Comments of Pacific Gas and Electric Company on the Draft CAISO 2012-2013 Transmission Plan and February 11, 2013 Stakeholder Meeting

Submitted by	Company	Date Submitted
<i>Mark Higgins, 415-973-5657</i>	<i>Pacific Gas and Electric Company (PG&E)</i>	<i>February 25, 2013</i>

Figure 1: PG&E Preferred Alternative for the Lockeford-Lodi Area 230 kV Development

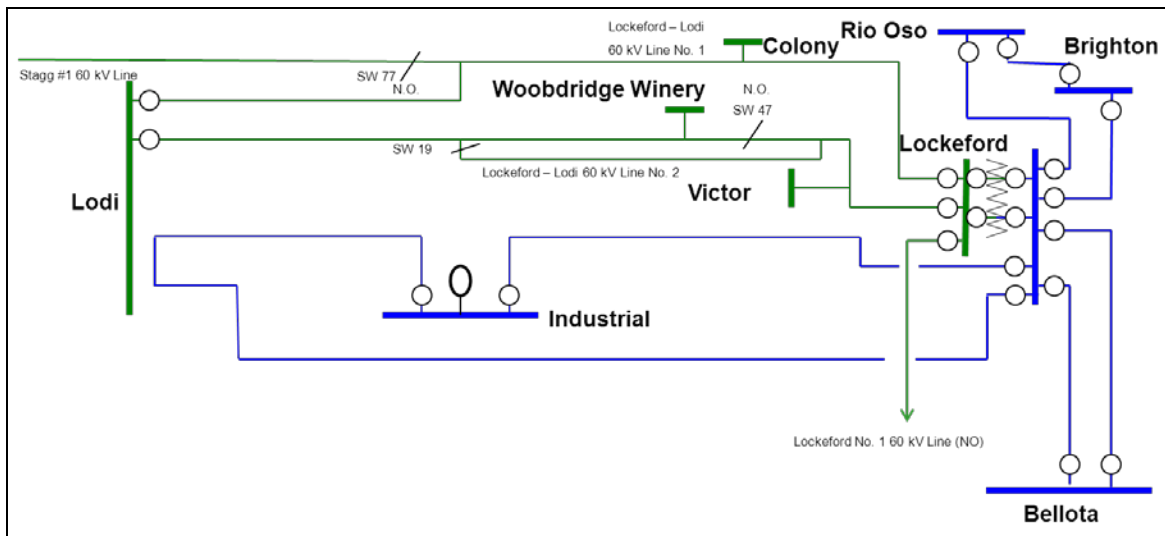
PG&E agrees with the CAISO’s reliability assessment and the need for a project in the Lockeford-Lodi 60 kV area to address reliability concerns. However, PG&E does not support the proposed plan of service detailed in the Draft 2012-2013 Transmission Plan.

This alternative would tie the Eight Mile and Lockeford 230 kV systems together and would require a thorough analysis of steady state and transient stability issues.

On a conceptual basis, PG&E prefers the option to install two new 230 kV circuits from Lockeford Substation to Industrial (see Figure 1 below). This is a more straight forward solution to the identified reliability concerns.

By serving the Industrial substation from one source, Lockeford Substation, this alternative eliminates PG&E's concerns with tying the Eight Mile and Lockeford 230 kV substations.
